**Re: Data Request on SCE West of Devers Upgrade Project Draft EIR/EIS
CPUC Application No. A.13-10-020**

Attachment 1: Responses to SCE Data Requests on Draft EIR/EIS

West of Devers Upgrade Project

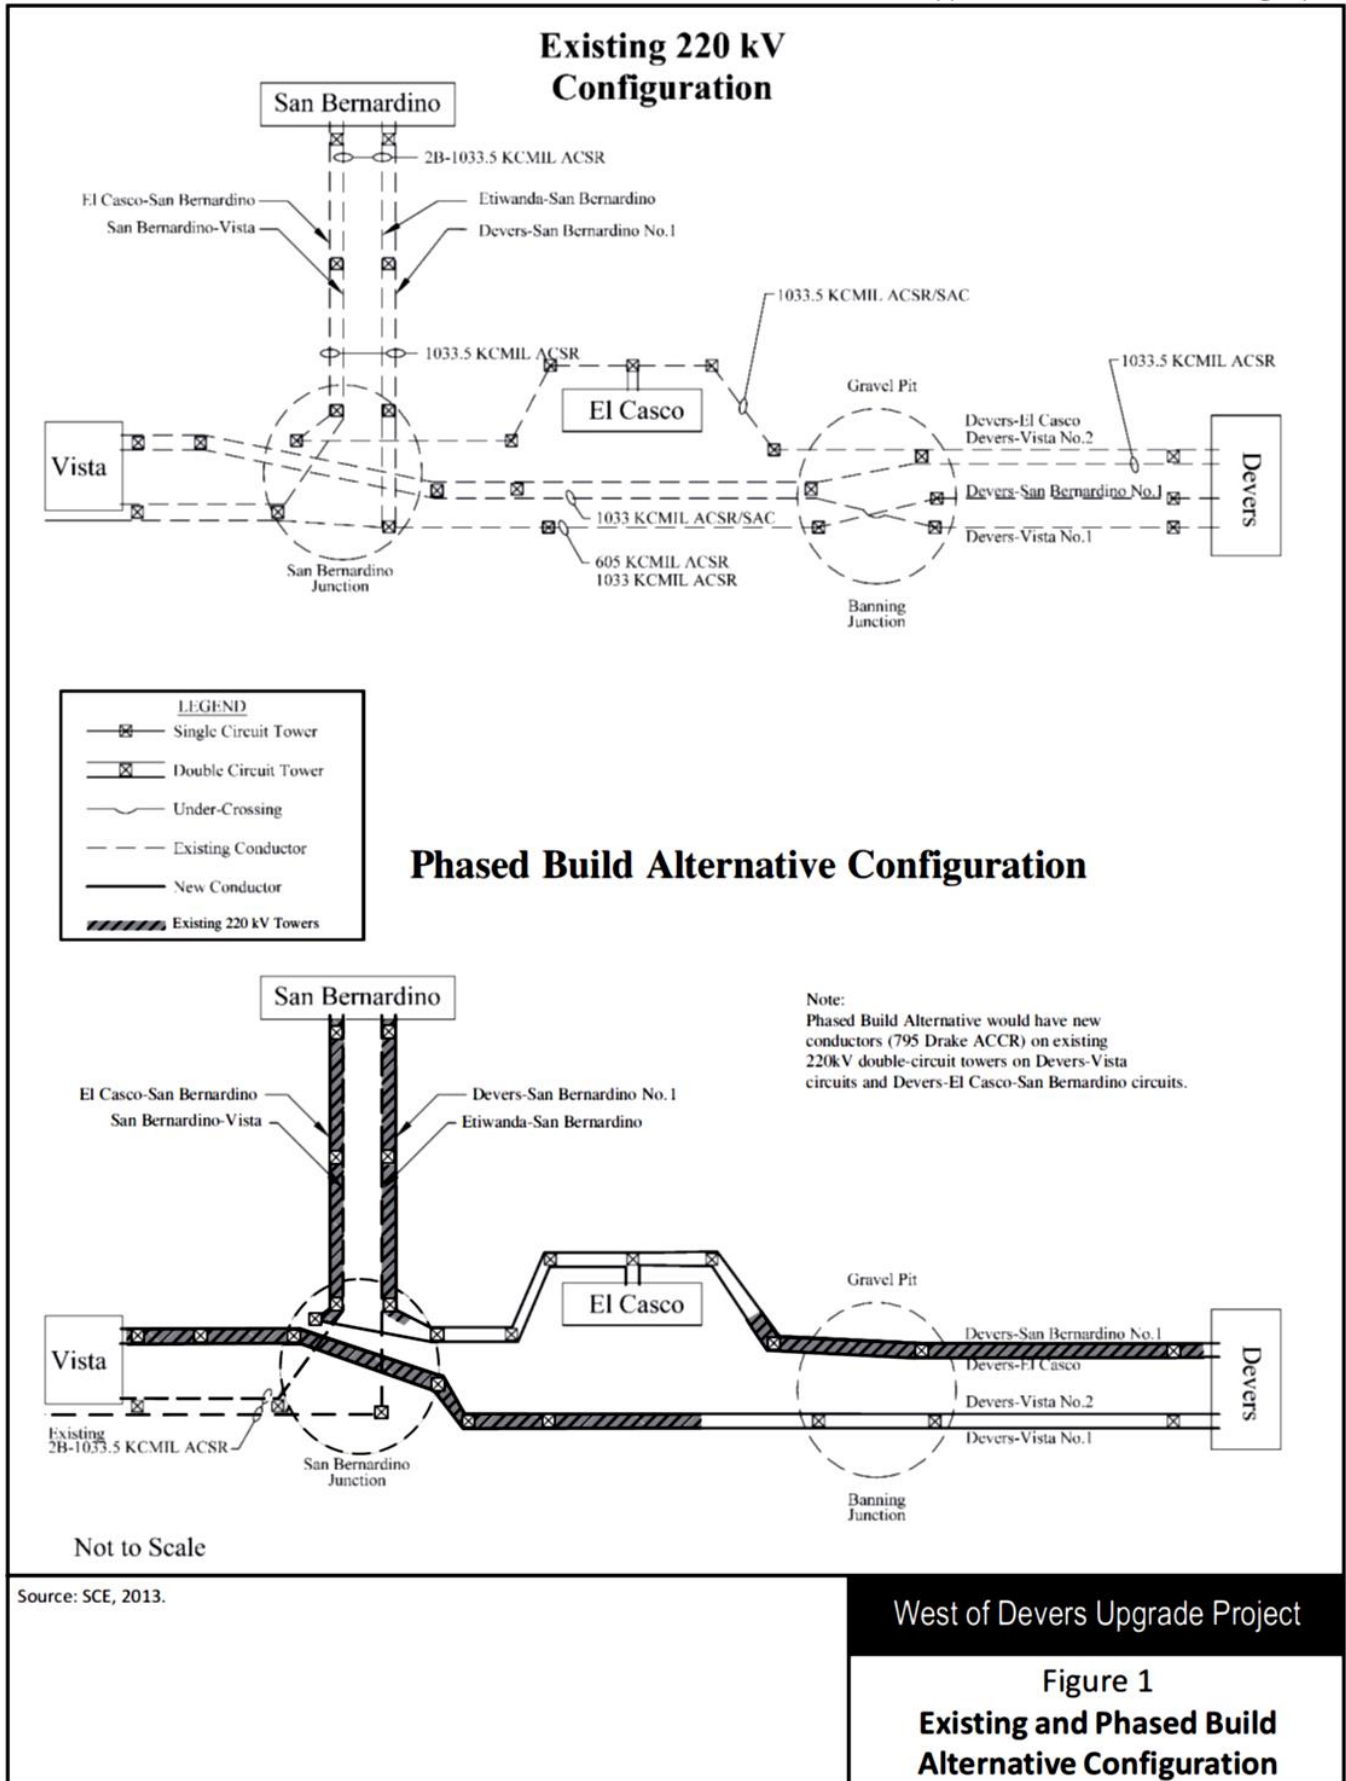
SCE Request #2: For the Phased Build Alternative, pp. Ap.5-47 describes the tower locations and lines for Segment 1 as keeping the existing towers and only reconductoring the circuits nearest the edges of the ROW, while Attachment 1, Figure 1, shows bundled 1033 ACSR on both circuits of the western towers and single 795 on both circuits of the eastern towers in Segment 1. Similarly, the subsequent descriptions of the circuit orientations on pp. Ap.5-47 and Ap.5-48 include the reconfigurations at San Bernardino Junction and Banning Junction, to place the Devers-El Casco-San Bernardino circuits in the northern part of the ROW, but this would conflict with stringing the Segment 1 corridor as described in the text. Please clarify the correct alignment and wire placement in Segment 1 for this alternative?

Response: One primary purpose of the Phased Build Alternative is to reduce required construction by retaining as many existing structures as possible (Draft EIR/EIS, Appendix 5, p. Ap.5-46). Therefore, the Phased Build Alternative would retain the existing double-circuit 220 kV towers and the San Bernardino–Vista and Etiwanda–San Bernardino circuits in their existing positions in Segment 1 without any changes (p. Ap.5-47). The only change to the 220 kV towers would be to reductor the circuits nearest the edges of the ROW (from El Casco and Devers, Figure Ap.5-5a).

The comment correctly notes that the text is slightly different from the Segment 1 configuration illustrated in the Draft EIR/EIS Appendix 5, Attachment 1, Figure 1 (p. Ap.5 Att.1-5). The Final EIR/EIS will clarify that the figure was schematic and will present a revised figure that more closely matches the text (p. Ap.5-47). The text of Appendix 5 correctly describes the Phased Build Alternative with a reductoring to replace the two existing circuits in the 220 kV positions nearest to the edges of the Segment 1 ROW. As a result, the Devers–San Bernardino and El Casco–San Bernardino circuits would use a new 795 Drake ACCR conductor (p. Ap.5-47). See the revised figure on the following page.
